**TECHNICAL EVALUATION REPORT (TER):  
REVIEW OF NMPC PROJECT 03-9425 REPORTS,  
"ELASTIC-PLASTIC FRACTURE MECHANICS ASSESSMENT OF  
NINE MILE POINT UNIT 1 BELTLINE PLATES FOR  
SERVICE LEVEL A AND B LOADINGS (MPM-USE-129215) AND  
SERVICE LEVEL C AND D LOADINGS (MPM-USE-293216)"**

**J. G. Merkle and D. K. M. Shum**

**December 21, 1993**

**Prepared for  
U.S. Nuclear Regulatory Commission  
Office of Nuclear Reactor Regulation  
Materials and Chemical Engineering Branch**

Fig 2.

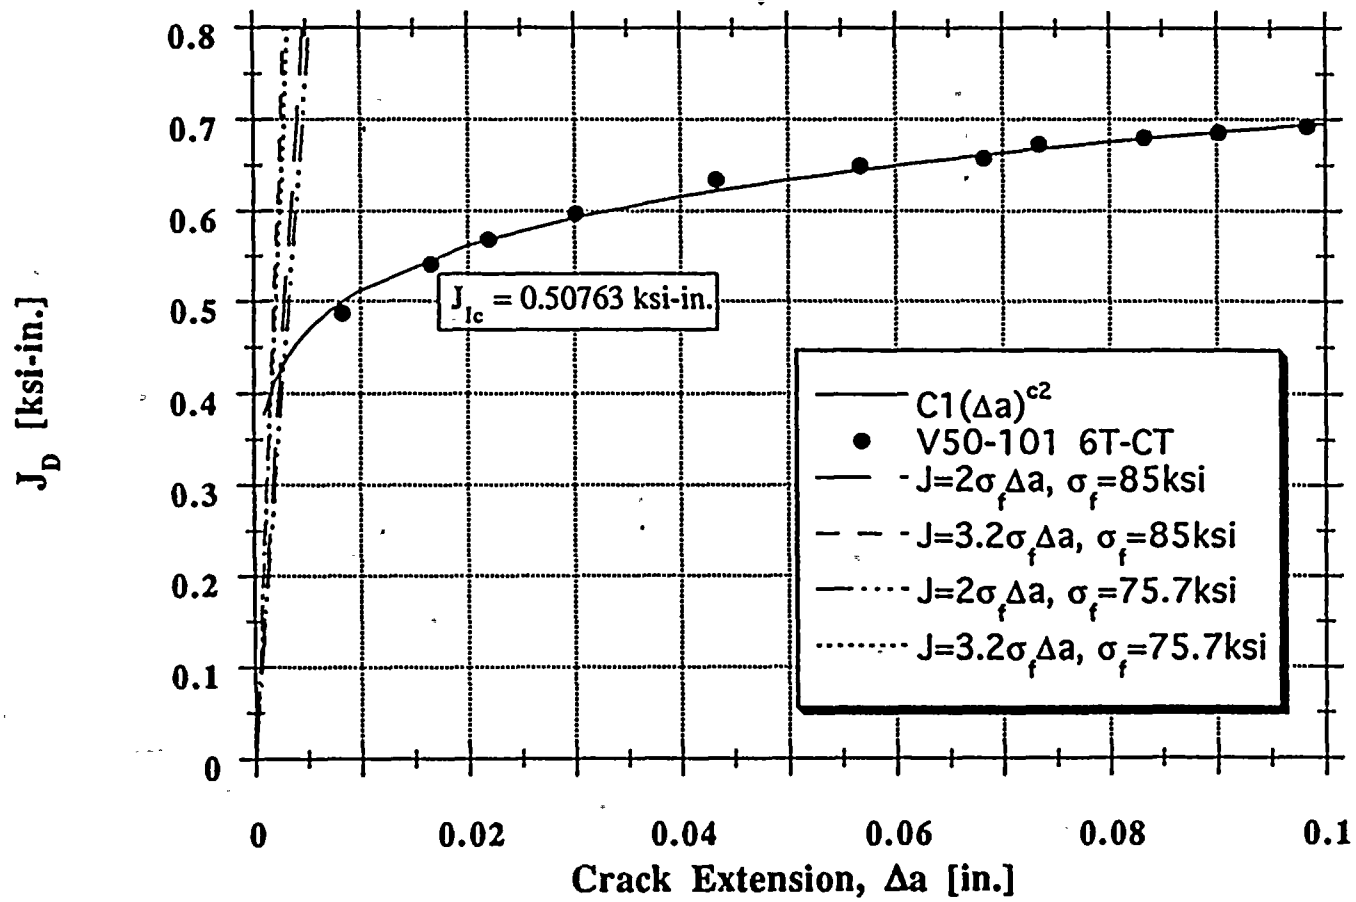
As shown in Fig. 2, the fit of Eq. (2) to the V50-101 data for  $\Delta a \leq 0.10$  in. is quite good. However, as shown in Fig. 3, the sudden decrease in slope of the measured J-R curve at  $\Delta a = 0.10$  in. causes the power law fit to become significantly unconservative for greater values of  $\Delta a$ .

Fig. 15

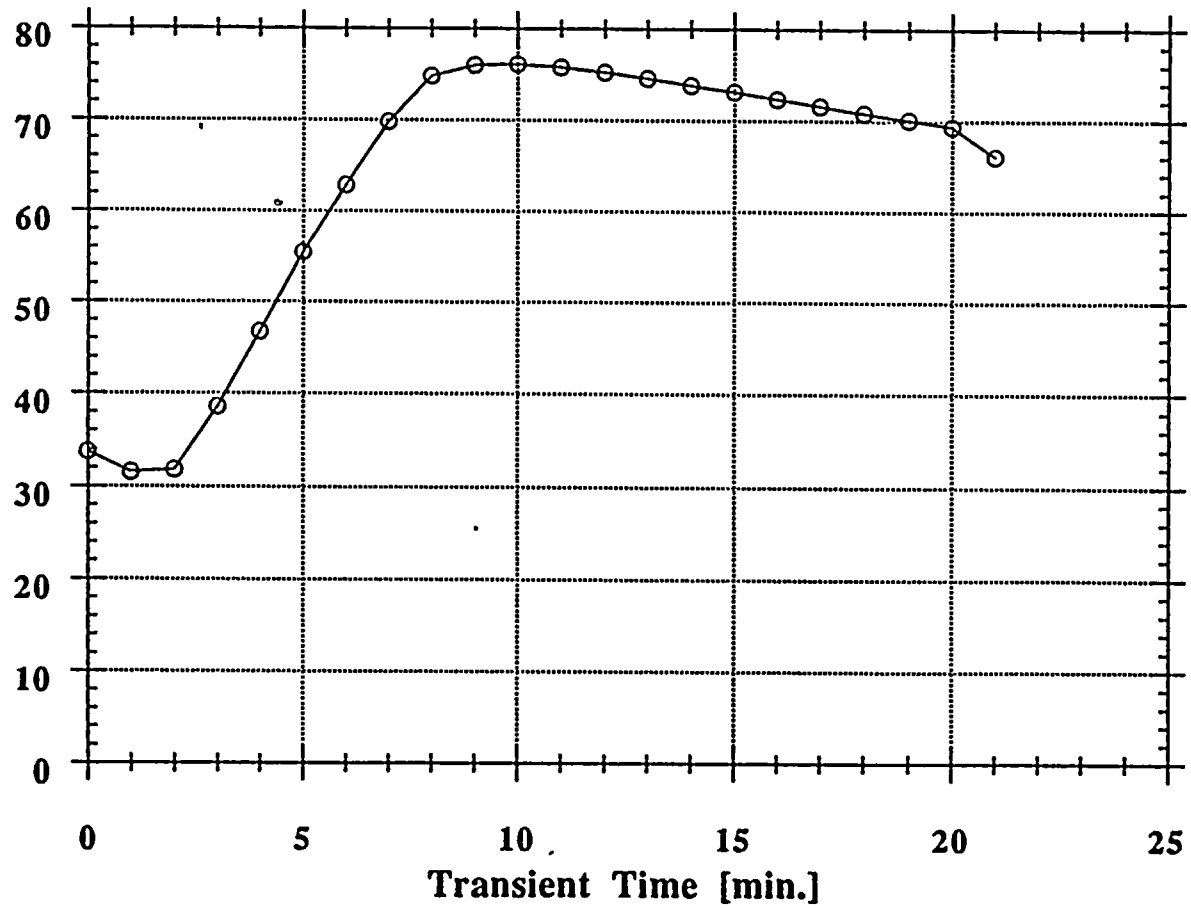
Checking calculations were performed for two transients, the Level C 250°F/7.5 min. blowdown and the Level D steam line break. Fig. 15 shows the time variation of  $K_I$  for the Level C transient, for a crack depth of  $a_0 + 0.10 \text{ in.} = 0.968 \text{ in.}$  The maximum value of  $K_I$  occurs at a transient time of about 10 minutes, close in time and magnitude to the values calculated in Ref. 2. At a transient time of 10 minutes, the through-wall temperature and stress distributions are as shown in Figs. 16 and 17. The comparison with Ref. 2 is good, although the cladding stresses shown in Fig. 17 are higher than those shown in Fig. 4-6 of Ref. 2. Fig. 18 shows the comparison between the applied value of  $K_I$  and  $K_{J,0.1}$  for the Level C blowdown transient. Considering the effect of temperature on  $K_{J,0.1}$ , the limiting value of  $CVN_R$  for an axial flaw is 13 ft-lbs. Calculations were not performed for a circumferential flaw, relying on Fig. 4-6 of Ref. 2 which shows that the axial stresses are less than the circumferential stresses. Using Eq. (9),  $OF = 1$  and  $UF = 0.7$ , the calculated EOL value of CVN for the LT direction is 22.5 ft-lbs., considerably greater than the value of 10 ft-lbs. given on p. 43 and in Table 5-3 of Ref. 2. Fig. 19 shows values of  $K_I$  calculated according to Ref. 13, with pressure set equal to the design pressure,  $P_d$ , which is 1250 psi. The Level C and D values of  $K_I$  bracket the maximum value of  $K_I$  calculated by FAVOR. If the toughness at operating temperature must be used to satisfy Code Case N-512 criteria,  $CVN_R = 25 \text{ ft-lbs.}$  and from Eq. (9) the corresponding LT value of CVN is 39.7 ft-lbs. K-R tangency plots for criterion #2 are shown in Fig. 20. Because Level C loads and toughness remain unchanged from criterion #1 to Criterion #2 and the knee of the J-R curve at which tearing instability occurs is assumed to be located at  $\Delta a = 0.10 \text{ in.}$ , satisfying one criterion implies satisfying

Fig. 21

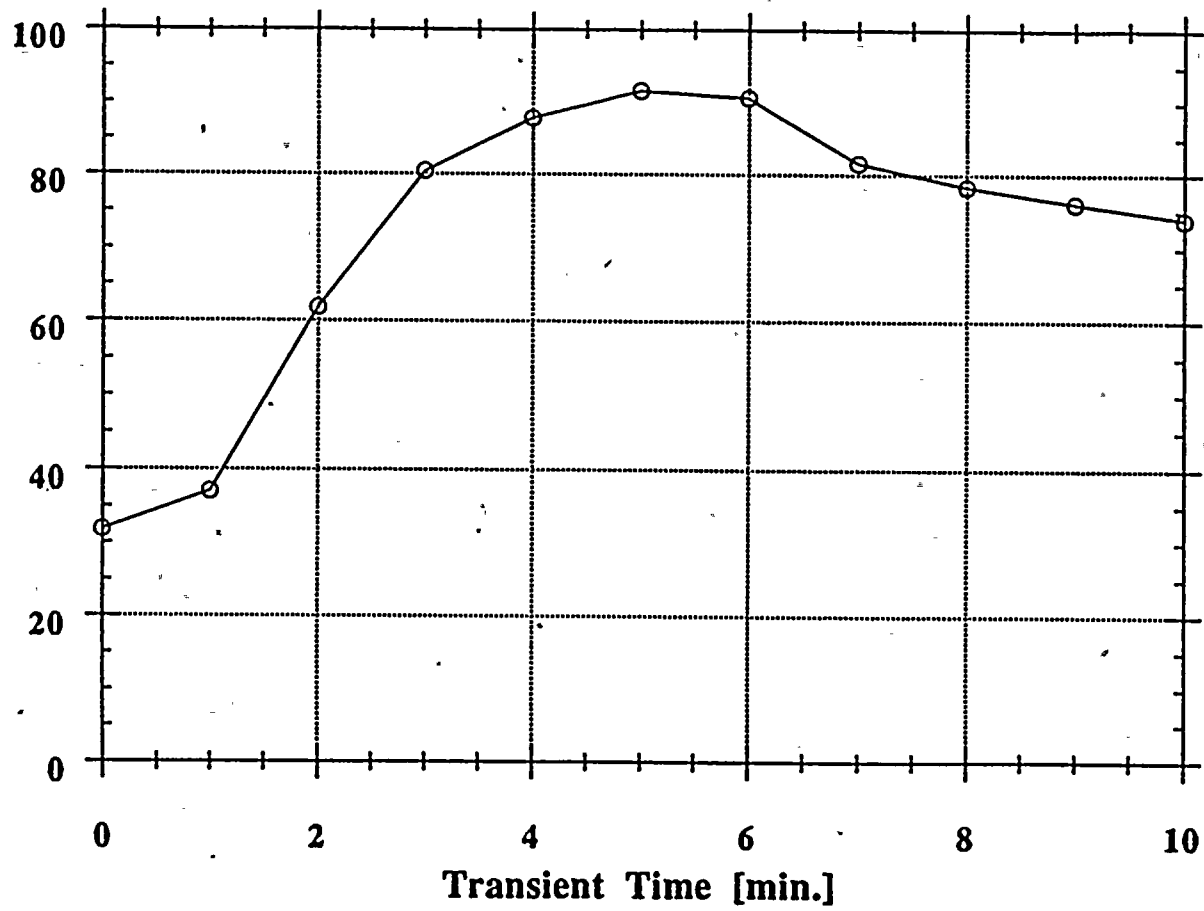
Calculations for the Level D steam line break transient followed the same sequence as those for the Level C transient, as shown by Figs. 21 thru 26. The difference between the two transients is made evident by comparing Figs. 15 and 21. The Level D steam line break transient produces a higher maximum value of  $K_I$  and the maximum occurs sooner in the transient, at a transient time of about five minutes instead of ten. This is close enough to the value of four minutes reported in Ref. 2. The crack depth used for analysis was 0.868 in. The maximum value of  $K_I$  also agrees well with Ref. 2. From Fig. 22, the crack tip temperature at the time of the maximum value of  $K_I$  is almost the same as for the Level C transient. The stress distribution at the same time shown in Fig. 23 also agrees well with Ref. 2, but again shows higher cladding stresses. The variation of applied  $K_I$  with crack tip temperature shown in Fig. 24 displays a sharp drop after the peak with a slight temporary increase in crack tip temperature. This phenomenon is due to the occurrence of a minimum in the heat transfer coefficient and the resulting redistribution of heat within the vessel wall. The temperature profiles in Ref. 2 show the same behavior. From Fig. 24, considering the variation of tearing resistance with temperature, the required value of  $CVN_R$  for an axial flaw is 21 ft-lbs., higher than the required value of 13 ft-lbs. for the Level C transient. From Eq. (9), using  $OF = 1$  and  $UF = 0.7$ , the calculated EOL value of CVN for the LT direction is 33.9 ft-lbs., considerably greater than the value of 20 ft-lbs. given on p. 43 and in Table 5-4 of Ref. 2. Fig. 25 shows the calculated  $K_I$  values based on Ref. 13 compared to those calculated by FAVOR. In this case, the calculations based on Ref. 13 are unconservative, probably because, as indicated in Table 3-2 of Ref. 2, the thermal transient is more severe than assumed in Ref. 13. The tearing instability diagrams based on the maximum value of  $K_I$  calculated by FAVOR, with and without considering the effect of temperature on the J-R curve, are shown in Fig. 26. Using a J-R curve corresponding to the operating temperature, 528°F, as prescribed for a steady state thermal analysis in Ref. 13, the required value of  $CVN_R$  is 36 ft-lbs., the same value obtained for Levels A and B, criterion #2. Thus the corresponding LT value of CVN is 55 ft-lbs., still below the lowest estimated EOL value for plate G-307-4.
